OFFICIAL COORDINATION REQUEST FOR NON-ROUTINE OPERATIONS AND MAINTENANCE

COORDINATION TITLE-16BON119 CI Count Station Crowder Install
COORDINATION DATE- 25 October 2016, updated on 23 November 2016
PROJECT- BON
RESPONSE DATE- 10 November 2016 (FPOM meeting)

Figure 1. Cascades Island fish ladder section where crowder install (red circle) will occur.

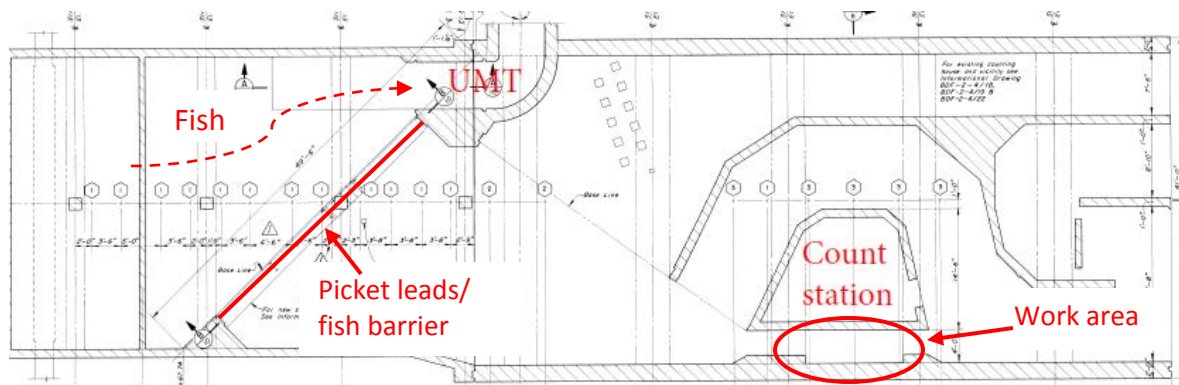
Erin, Overall, I don't have any issues with conducting the proposed work as indicated, however, I think the MOC could be a bit clearer on what the impact will be to adults passing the CI ladder. For 20 minutes on 14 and 17 November, fish passage in the CI ladder will be interrupted (not everyone understands the function of the UMT or that the CI exit will still be closed). Also, for the four days of the work period, the head on many of the weirs in the CI ladder will be approximately one half foot, half of normal. This will reduce orifice flow and velocity and may reduce passage efficiency. We can discuss further at FPOM if necessary. Thanks, Gary

Final results – FPOM concurred with this action at the November FPOM
